**MONTGOMERY COUNTY HISTORIC PRESERVATION COMMISSION**  
**STAFF REPORT**

<b>Address:</b>	10310 Freeman Place, Kensington	<b>Meeting Date:</b>	12/21/2022
<b>Resource:</b>	Primary One Resource <b>Kensington Historic District</b>	<b>Report Date:</b>	12/14/2022
<b>Applicant:</b>	Daniel Martin	<b>Public Notice:</b>	12/7/2022
<b>Review:</b>	HAWP	<b>Staff:</b>	Dan Bruechert
<b>Case Number:</b>	<b>REV 998841</b>	<b>Tax Credit:</b>	n/a
<b>Proposal:</b>	Partial demolition, rear addition, new landing and stairs, and new shutters.

*Figure 4: Proposed side entrance. New window outlined in Red.*

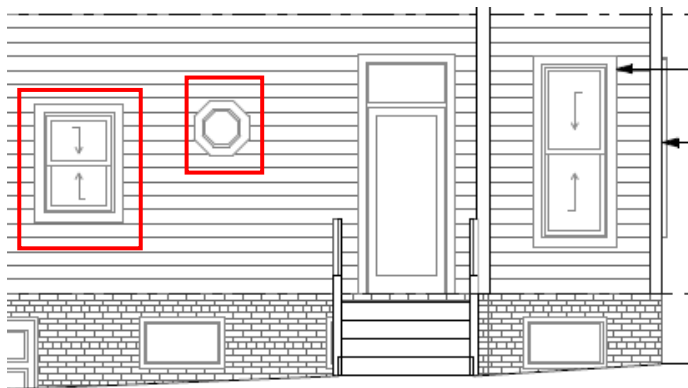
The applicant proposes to install a new full-lite steel door with a simply detailed porch with an iron handrail with pickets. Material specifications for the porch stairs and landing were not included with the HAWP application materials. Staff finds that a steel door in the historic c.1895 construction is an incompatible material and any new door needs to be wood. Steel does not develop a patina and lacks the material characteristics of wood. Staff finds a full-lite door is an acceptable design, but would accept a half-lite door as being compatible with the character of the house and surrounding district. Staff recommends the HPC include a condition for approval to the HAWP that the new door be wood. Staff would ordinarily consider the porch proposal incomplete because no material was specified in the submitted application. However, because this new porch is attached to the historic fabric in a location that fronts the public right-of-way, Staff finds the only acceptable material is wood. Staff additionally recommends the HPC include a condition for approval that the new stairs and landing be wood, with final verification approval delegated to Staff.

2. The stairs and decking for the proposed side porch need to be wood. Permit drawings identifying the porch material need to show wood. Final approval authority to verify this condition has been satisfied is delegated to Staff.

*Figure 6: New window opening outlined in red.*

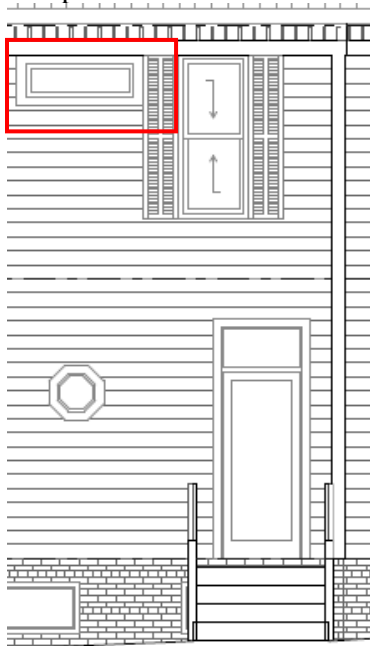
The final change proposed for the right elevation is the installation of a wide fixed aluminum-clad window above the hexagonal window discussed above. The window is opposite a proposed interior bathtub. Staff finds the configuration and proportions of the window are incompatible with the historic character of the house and recommends the HPC not approve the new window, finding the proposal contravenes Standard 2 and 24A-8(b)(2).

The applicant could increase light into the bathroom by altering the room layout or installing a transom around the enclosed toilet area. The sun tunnel, discussed above should bring additional natural light into the space.

5. The wide fixed window on the second floor of the right elevation is incompatible with the character of the house and may not be installed. Final approval authority to verify this condition has been satisfied is delegated to Staff.

Proposed Left Elevation  
3/16" = 1'-0"

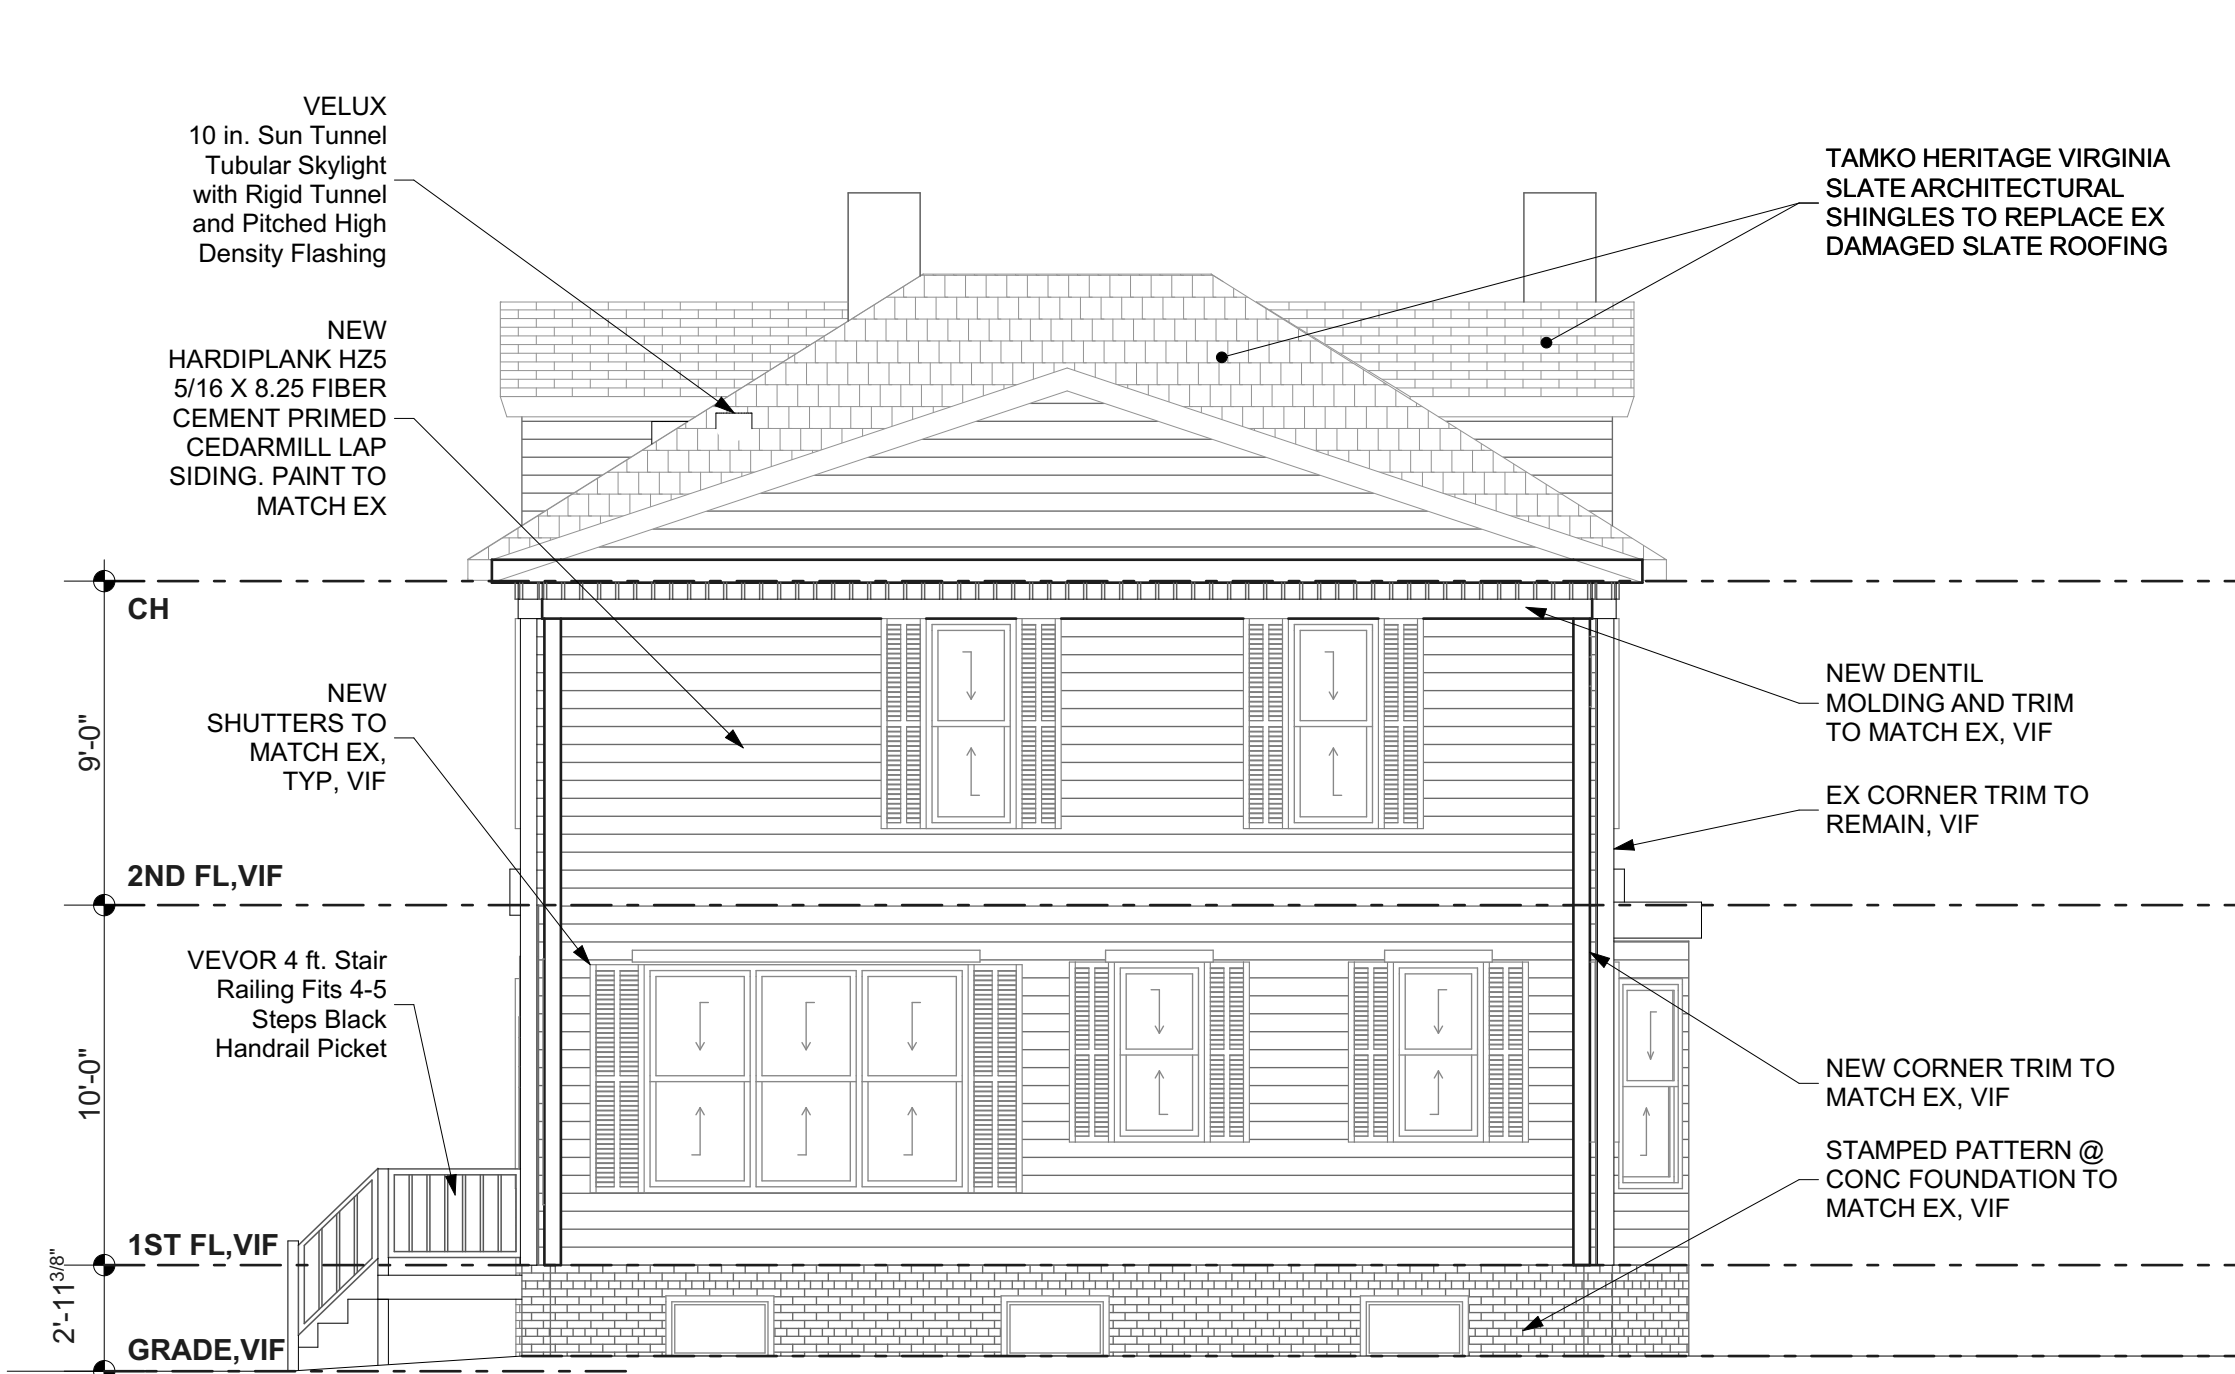
On the rear of the left elevation, the applicant proposes removing and replacing the windows in the rearmost opening on both the first and second floors. On the first floor, there is a pair of sash windows without shutters. On the second floor, there is a sash window with shutters. No information about the condition of the existing windows was included in the application. The applicant proposes to install new aluminum-clad windows with wood shutters in their place.

Staff finds the paired first-floor windows are not historic. Paired window configurations were developed later than the late 19<sup>th</sup>-century house construction date. Additionally, this is the only location where windows are paired. The window on the second story, however, appears to be historic. Staff finds the documentation required to evaluate these windows is incomplete and any decision the HPC renders on this HAWP cannot extend to the window replacement.

7. The condition of the existing roof and windows on the left elevation is not documented and the approval of this HAWP does not extend to the roof or window replacement. A detailed report on the condition of the existing slate roof and sash windows can be submitted to this office for evaluation as a new HAWP.

Proposed Right Elevation  
3/16" = 1'-0"

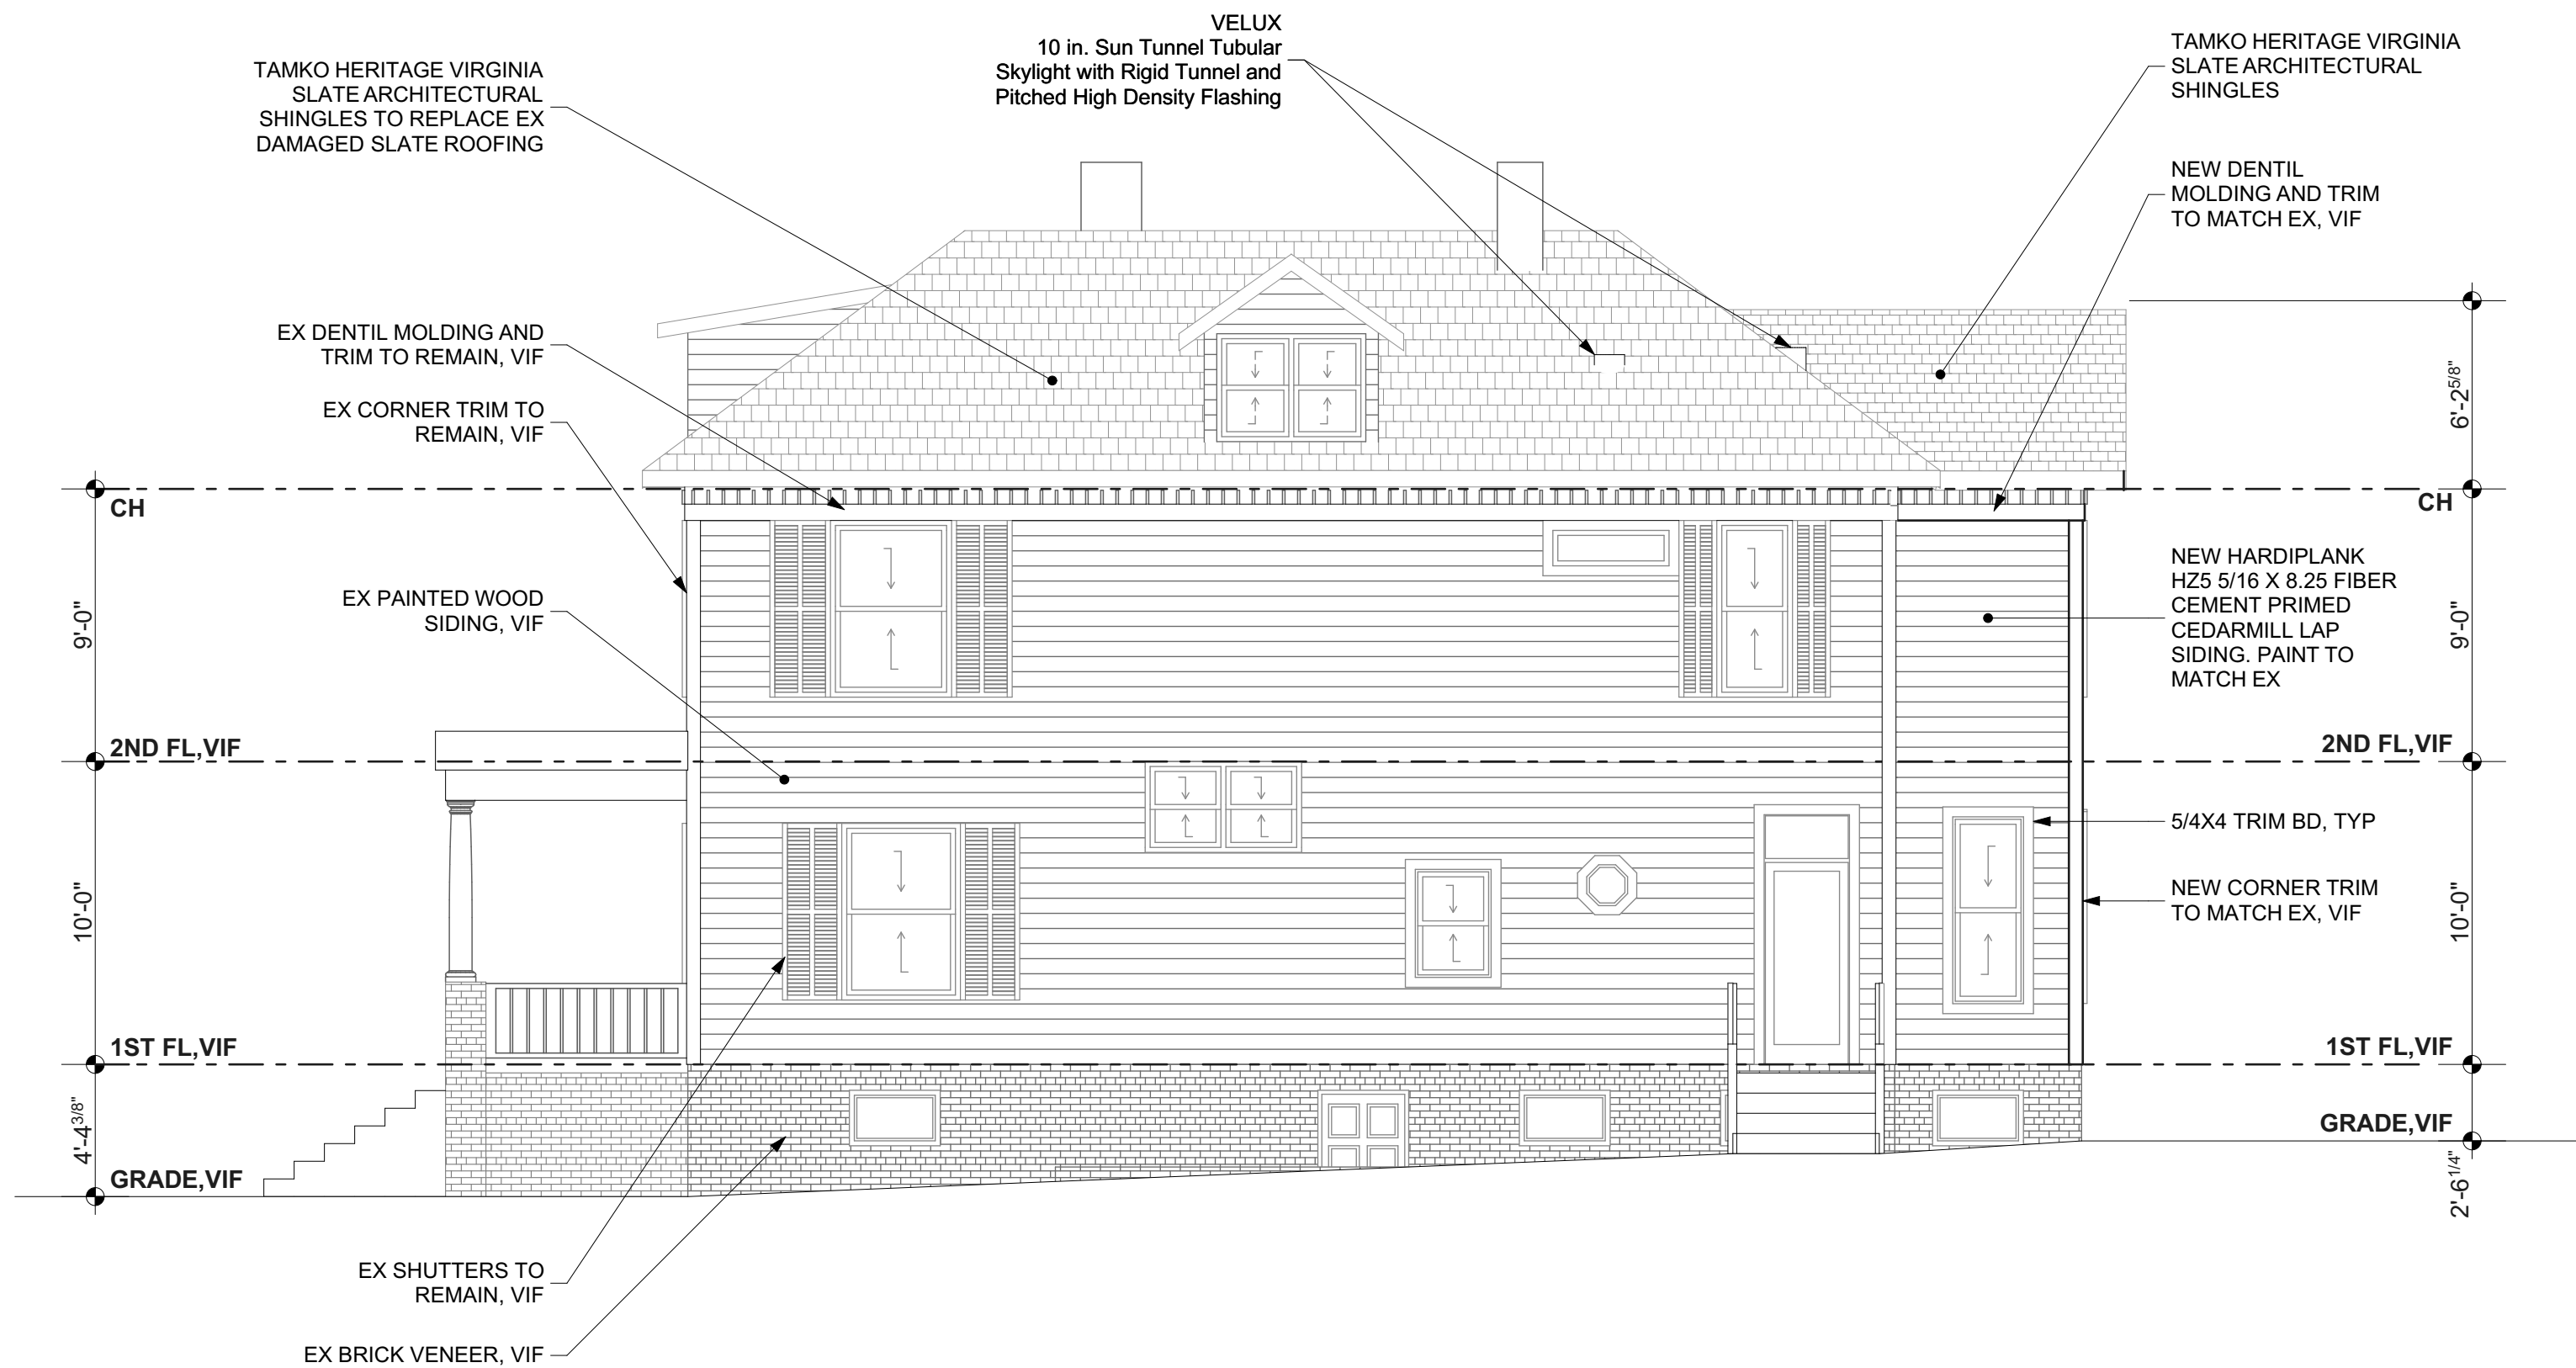
On the right elevation (facing Warner St.) the applicant proposes to install two Velux Sun Tunnels, one on the side (street-facing) roof slope and the other on the rear roof slope. Staff finds that the proposal for the rear roof slope will not have a significant impact on the character of the house. However, Staff recommends not extending that approval to the street-facing sun tunnel for reasons similar to ones previously articulated by the HPC in not allowing street-facing skylights, namely: the materials are incompatible with the roofing material, they change the roof profile, and interrupt the flat plane of the roof surface. Staff recommends the HPC only approve the rear roof slope sun tunnel and delegate verification that this condition has been satisfied to Staff.

To the left of the proposed door, the applicant proposes to install a fixed hexagonal window and a new sash window. Staff finds this small window would not have a substantial impact on the character of the elevation and finds the fixed window preferable to the small sash windows installed opposite the main staircase on the right elevation. Staff recommends the HPC approve this small window. To the left of the hexagonal window, the applicant proposes to install an aluminum-clad sash window. Staff finds a window in this location is acceptable, because the walk plane is a large expanse of uninterrupted clapboards. However, Staff does not support introducing a fourth different size of sash window on this elevation. Staff recommends the HPC approve this new sash window but include a condition that the window needs to match the size of the second-floor window directly above the proposed door. This would create an appearance that is more visually compatible with the historic character of the house and avoid creating an elevation where virtually every opening is a different size.

3. The sun tunnel on the right, street-facing elevation is not approved and may not be constructed. Final permit drawings may not include this element. Final approval authority to verify this condition has been satisfied is delegated to Staff.

4. The first-floor sash window on the right elevation needs to be enlarged so that it matches the dimensions of the historic second-floor window. Final approval authority to verify this condition has been satisfied is delegated to Staff.
